Access Compliance Report

Public Rights-of-Way (Curb Ramps)

Intersection ID: 3879	Main Street: DAVIS_LAKE_PY	Cross Street: DEER_CROSS_TL	Location: SE
ADA ID: 735394BF9976	Ramp Type: Perp	Initial Pass/Fail: Fail	Overall Compliance: No
		Severity Score: 35

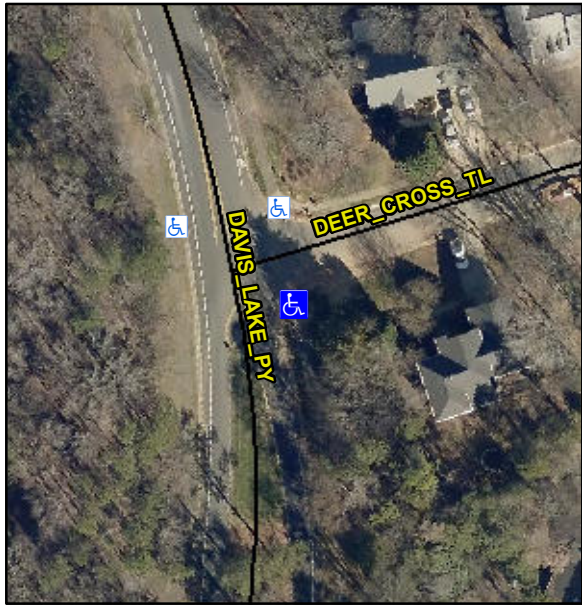
Codes/Mitigation Info/Possible Solution			Field Measurements/Component Compliance					
	Possible Solutions:		Compliance	Description	Data	Compliance	Description	Data
	Remove & Replace Entire Ramp.		N/A	Ramp Length (in)	44.0	No	Ramp Slope (%)	24.2
			No	Ramp Width (in)	42.0	No	Ramp XSlope (%)	2.8
			N/A	Flare Type LT	N/A	N/A	Flare Type RT	N/A
			N/A	Flare Slope LT (%)	N/A	N/A	Flare Slope RT (%)	N/A
			N/A	Flare Traversable LT?	N/A	N/A	Flare Traversable RT?	N/A
			N/A	Landing Length (in)	N/A	N/A	DWS Provided?	N/A
			N/A	Landing Width (in)	N/A	N/A	DWS Contrast?	N/A
			N/A	Landing Slope (%)	N/A	N/A	DWS Length (in)	N/A
			N/A	Landing X Slope (%)	N/A	N/A	DWS Full Width?	N/A
Surveyor Notes:			N/A	Landing Curb? (Y/N)	N/A	N/A	DWS Offset (in)	N/A
N/A			N/A	Shared Landing?	N/A			
PROW/ADA:			N/A	Gutter Ponding?	N/A	N/A	Gutter Slope (%)	N/A
Not Found, R304.5.1, R304.2.2, R304.5.3			N/A	Gutter Lip Ht (in)	N/A	N/A	Gutter X Slope (%)	N/A

N/A	Painted X Walk1?	No	N/A	Painted X Walk2?	N/A
				X Walk 1 Direction	To N		X Walk 2 Direction	N/A
			N/A	X Walk 1 Width (in)	N/A	N/A	X Walk 2 Width (in)	N/A
				X Walk 1 Slope (%)	1.6		X Walk 2 Slope (%)	N/A
				X Walk 1 X Slope (%)	0.6		X Walk 2 X Slope (%)	N/A
			N/A	Ramp inside XWalk1?	N/A	N/A	Ramp inside XWalk2?	N/A
				Road Slope (%)	N/A	N/A	Clear Space?	N/A
				Road X Slope (%)	N/A	N/A	Clear Space to XWalk (in)	N/A
			N/A	Any Obstructions?	N/A	N/A	Storm Grate/Utility Hazard?	N/A
				Obstruction Type			Storm Grate/Utility Type	
						N/A		N/A
						Yes	Surface Condition? (G/P)	Good
